SUBJECT: Responds to request for addl info re automatic bus transfer feature for certain auxiliary feedwater (AFW) sys components per TMI Item II.E.1.2. Encl study justifies maintaining existing transfer for AFW Valve V2-16A.

H. B. ROBINSON STEAM ELECTRIC PLANT, UNIT NO. 2
DOCKET NO. 50-261/LICENSE NO. DPR-23
NUREG-0737, ITEM II.E.1.2
AUXILIARY FEEDWATER SYSTEM AUTOMATIC
INITIATION AND FLOW INDICATION

AUTOMATIC BUS TRANSFER STUDY

SINGLE LINE ELECTRICAL DIAGRAM (AFW VALVE V2-16A)

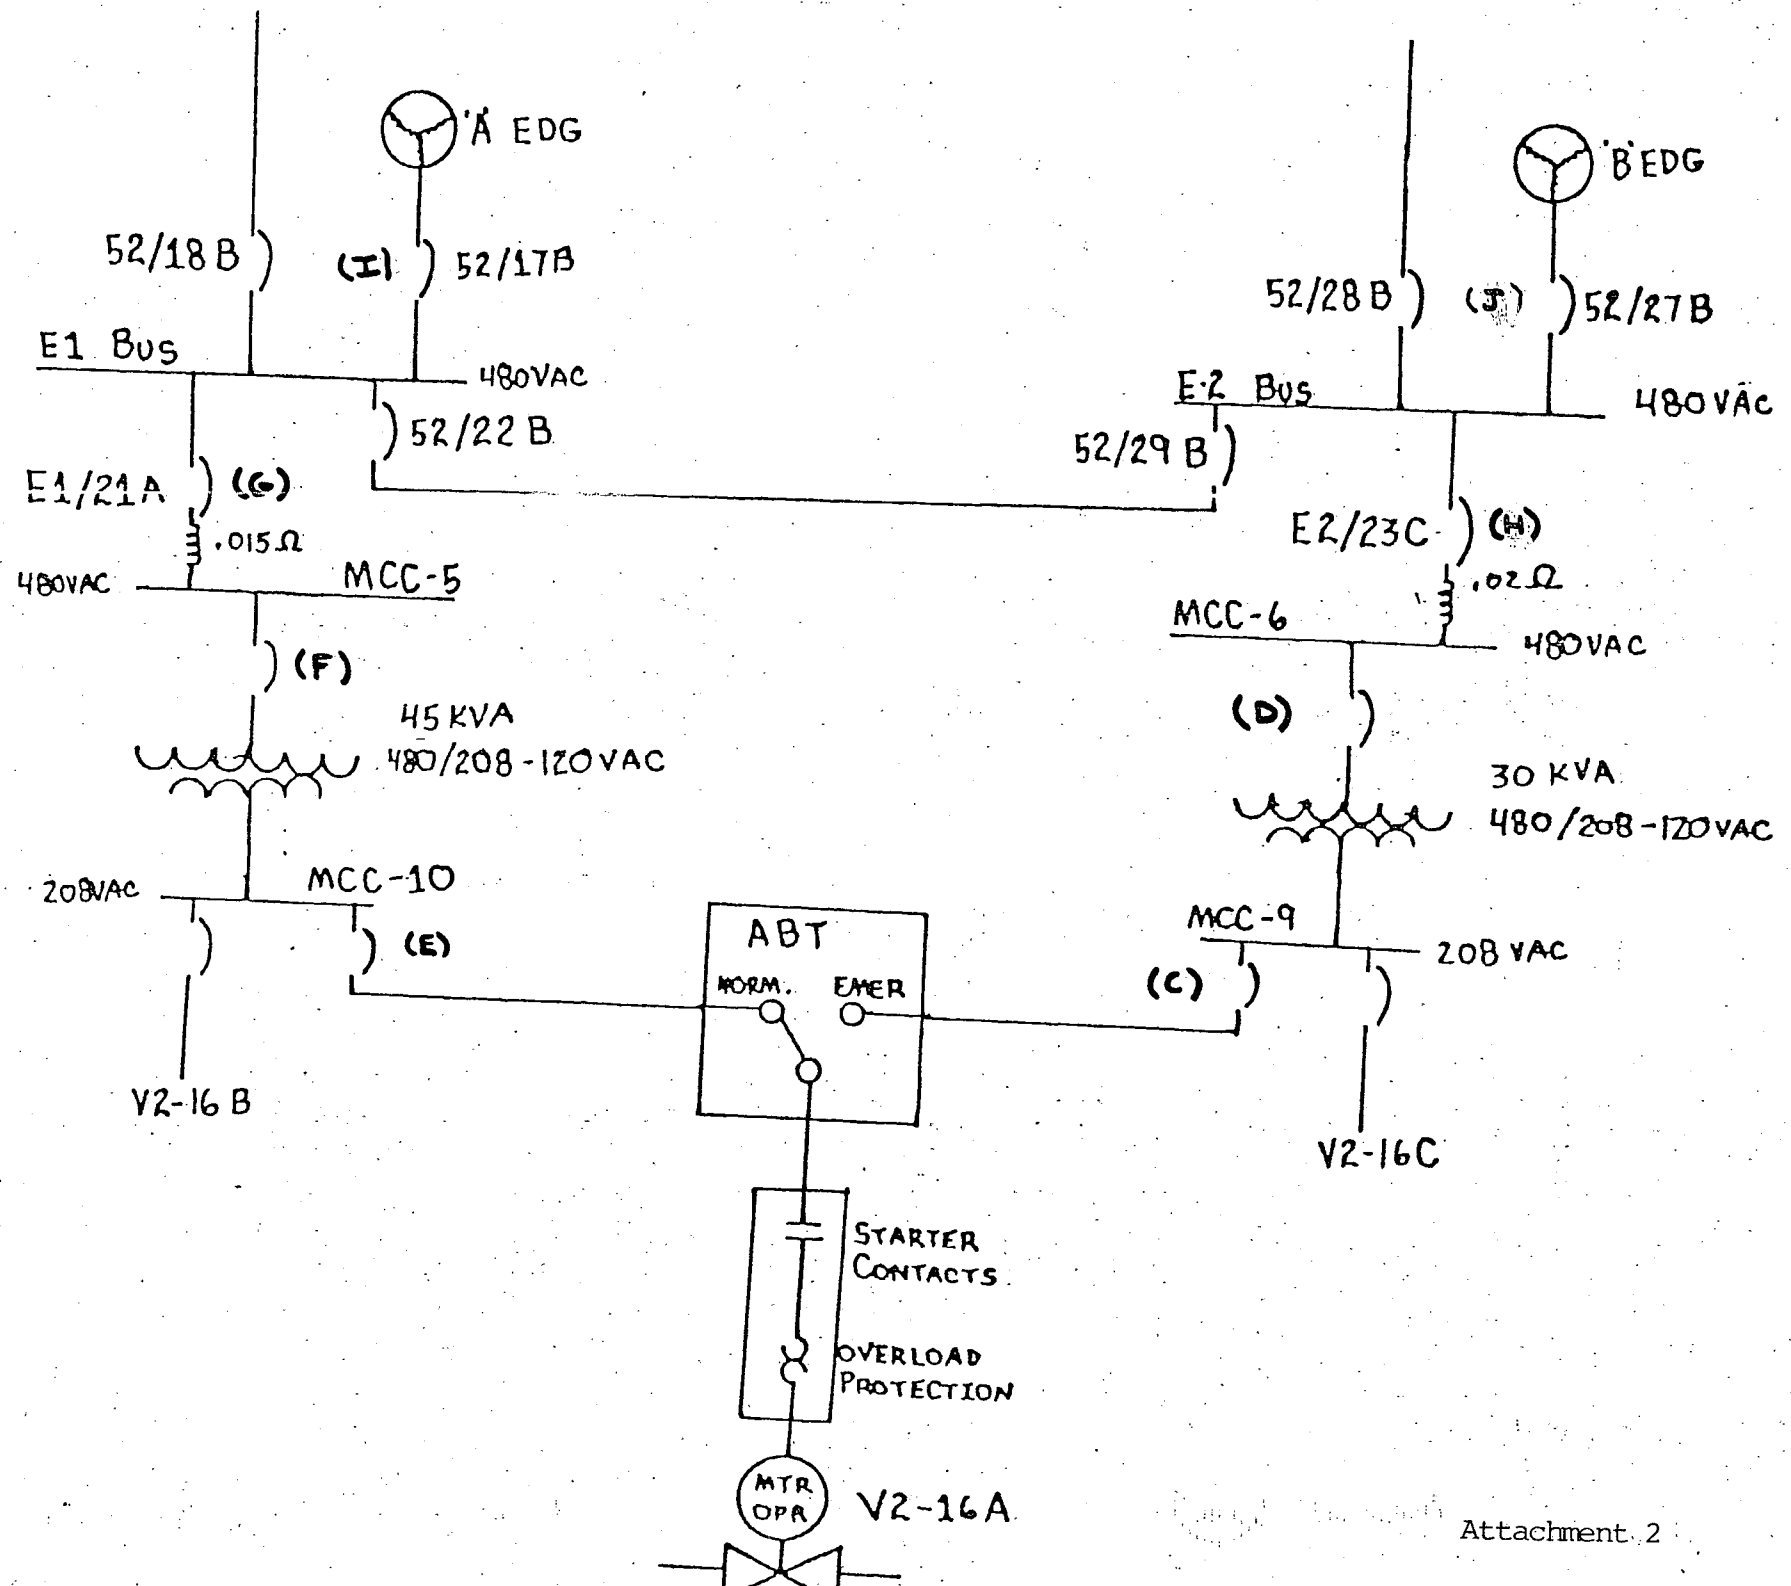
Motor-driven Auxiliary Feedwater System (AFWS) pump discharge valve V2-16A is normally powered from Motor Control Center (MCC) 10. An ABT is provided to transfer the power source for this valve to MCC-9 if MCC-10 becomes unavailable. The staff's position is that electrical independence must be maintained between redundant emergency power sources. The slightly improved defense against a random single failure achieved by the ABT is more than offset by the additional vulnerability to the common mode failure which is created. The staff position is that this ABT feature provides a connection between redundant load groups and should be removed. Carolina Power & Light Company has stated that the breaker scheme employed would prevent the transfer of a fault from one bus to another.

The staff's position is that this is not sufficient justification for the ABT and that faults within the ABT or within the valve itself present potential unnecessary challenges to these protective devices. The staff also mentioned that they understand that certain AFWS automatic initiation signals only start the motor driven AFWS pumps. Given certain single failures, in the absence of the ABT, initiation of flow to two steam generators will be delayed until the steam driven AFWS pump starts. The staff believes, however, that this delay (which only occurs given a certain single failure) is insignificant as opposed to challenging redundant safety systems via the ABT.

Attachment 1 is a simplified Auxiliary Feedwater (AFW) system drawing and Attachment 2 is a single line electrical diagram showing the power supplies to AFW valve V2-16A.

The ABT is a true double throw switch designed as "break before make," and is inherently interlocked both mechanically and electrically. Failure of any coil, or disarrangement of any part will not permit a neutral position or a cross connect between power sources. The main contact is mechanically positioned on either source without the use of hooks, latches, semi-permanent magnets or springs and does not depend on a source of power to maintain its position. Therefore, due to this mechanical and electrical interlock, MCC-9 should not cross connect to MCC-10 through the ABT.
